Project	IEEE 802.16 Broadband Wireless Access Working Group < http://ieee802.org/16 >	
Title	Consolidation proposal according to 4 frame structure	
Date Submitted	2007-05-09	
Source(s)	Wu Xuyong, Huawei	Voice: +86-755-28973547 Fax: wuxuyong@huawei.com ,
Re:	IEEE 802.16-07/010: IEEE 802.16 Working Group Letter Ballot Recirc #24a: Announcement (2007-02-01)	
Abstract	According to 4 frame structure, some compliant consolidation should be made within CSI scheduling and the subframe reallocation mechanisms.	
Purpose	To consolidate the 16h draft.	
Notice	This document has been prepared to assist IEEE 802.16. It is offered as a basis for discussion and is not binding on the contributing individual(s) or organization(s). The material in this document is subject to change in form and content after further study. The contributor(s) reserve(s) the right to add, amend or withdraw material contained herein.	
Release	The contributor grants a free, irrevocable license to the IEEE to incorporate material contained in this contribution, and any modifications thereof, in the creation of an IEEE Standards publication; to copyright in the IEEE's name any IEEE Standards publication even though it may in

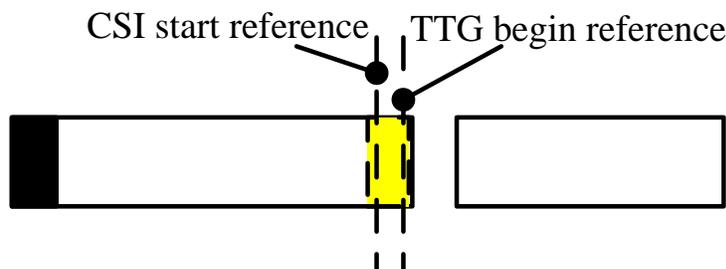
Comment: The allocation map is just internally stored information and should not be spec'd..

Suggested Remedy: Delete the last sentence of the paragraph..

Reply by Wu Xuyong: see contribution C80216h-06_114r3.

Group Resolution: Delete "By recognizing the OCSI allocation map (See 15.3.1.1.1),"

Figure h37- Timing of CSI bit unit

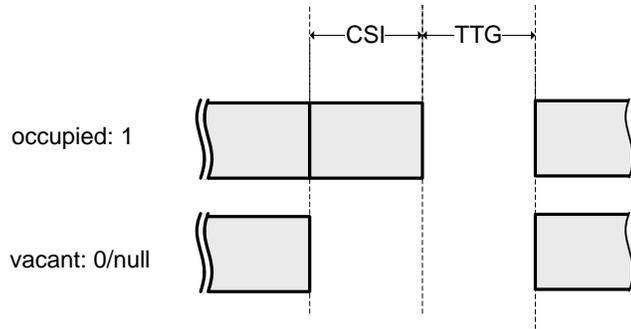
For the transmission side (BS), to use CSI duration as part of the data burst and ~~continues to stop~~ transmission at or later than $T_{CSISREF}$ (10.5.4) indicates bit one, while to stop transmission at ~~the beginning of CSI duration or before $T_{CSISREF}$~~ (10.5.4) indicates bit zero. (See Figure h37. below) While the receiver side is using the signal strength during the CSI duration to decode the carried bit, in periodical CSI slots allocated for each transmitter, the receiver is de facto demodulate energy keying or so called on/off keying signal. The detail of the receiving algorithm is out of the scope of this standard.
